City of Kingston
Report to Kingston Heritage Properties Committee
Report Number HP-24-030

Subject: Application for Ontario Heritage Act Approval

Address: 81 Gore Street (P18-938)

File Number: P18-051-2024

New Exterior Finish:

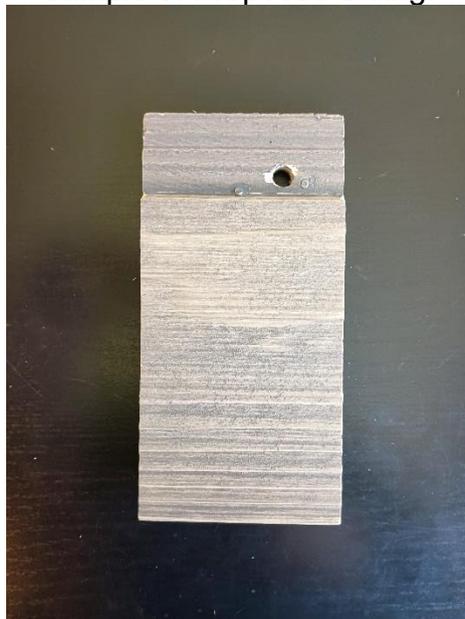
Another member recommended that the owner retain photographic evidence of the original siding. Further, they recommended that the owner use a different tone for the rear addition and/or use ribbon board detailing to better distinguish the original building from the new additions.

I understand why the owners of this home decided not to replace the brick façade on this heritage home. The applicant has put forth logical and practical siding choices though I wish there had been renderings of what the completed building would look like. Perhaps renderings could be circulated before a decision is made at the Committee meeting.

1. That the applicant consider using a slightly different colour tone for the rear addition to further differentiate new versus old;
2. That Heritage Planning staff review/approve the finalized window surrounds/trim and other wood accents for the rear addition to ensure they are appropriately sympathetic but differentiated from the original building;
